REV. E

AS3246™

ISSUED 1980-07 REAFFIRMED 2007-06 REVISED 2020-08

BOLT, MACHINE - DOUBLE HEXAGON EXTENDED WASHER HEAD, DRILLED, PD SHANK, NICKEL ALLOY, UNS N07718, 185 KSI MIN, .3750-24 UNJF-3A

FIGURE 1 - BOLT

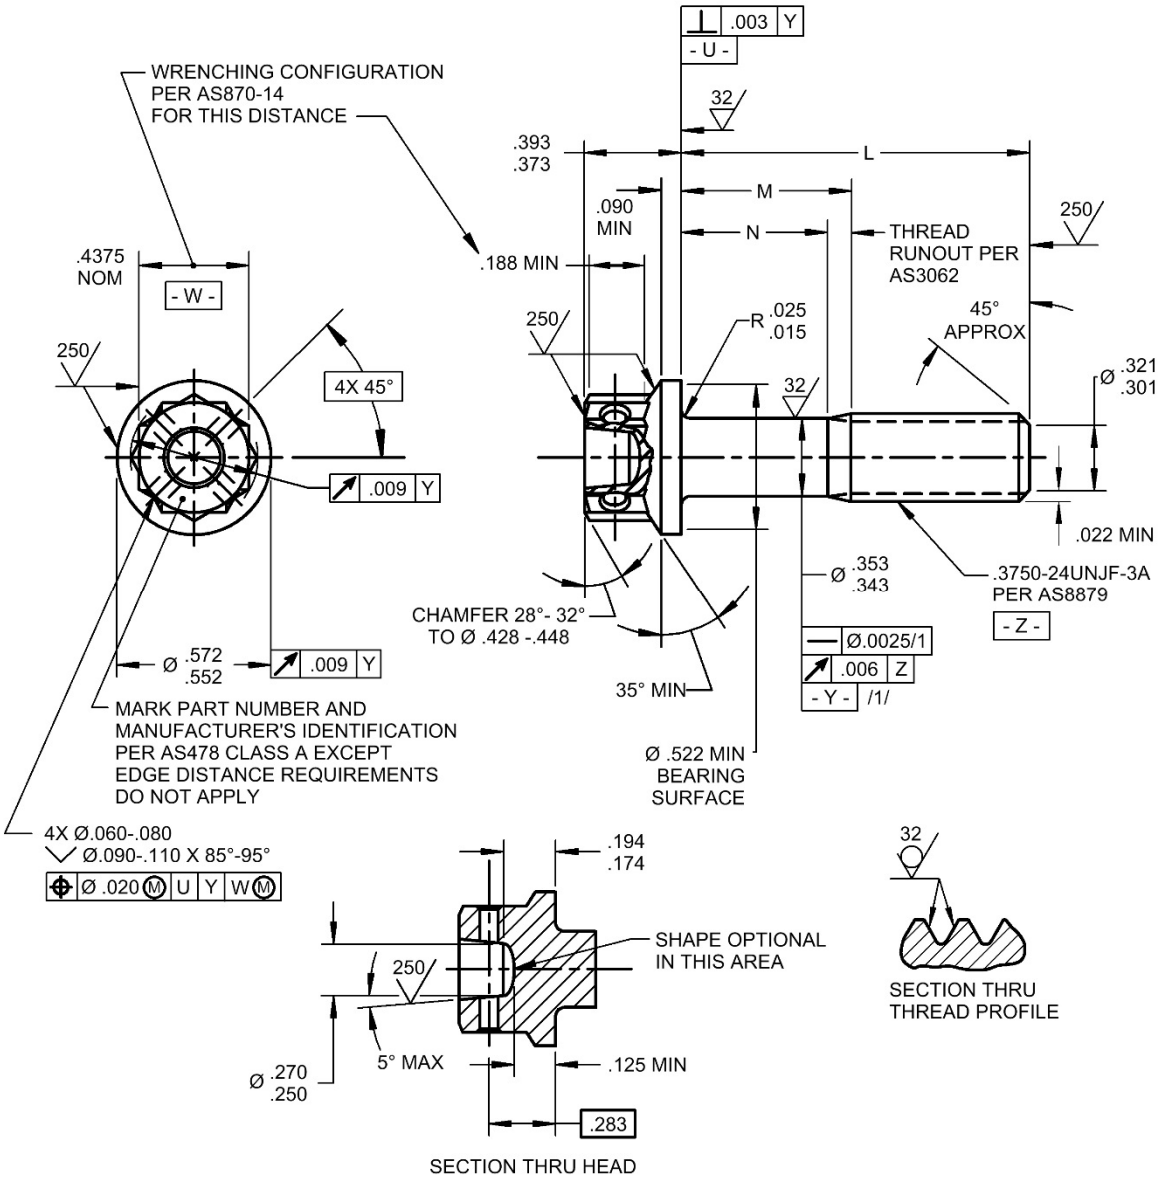
REVISE LEAD THREAD CHAMFER PER AS1132, ADD NEW NOTE FOR DISPOSITION OF EXISTING INVENTORY, ADD DATUM Y TO POSITION REQUIREMENT FOR DRILLED HOLES, RELOCATE W DATUM, GENERAL EDITORIAL UPDATES.
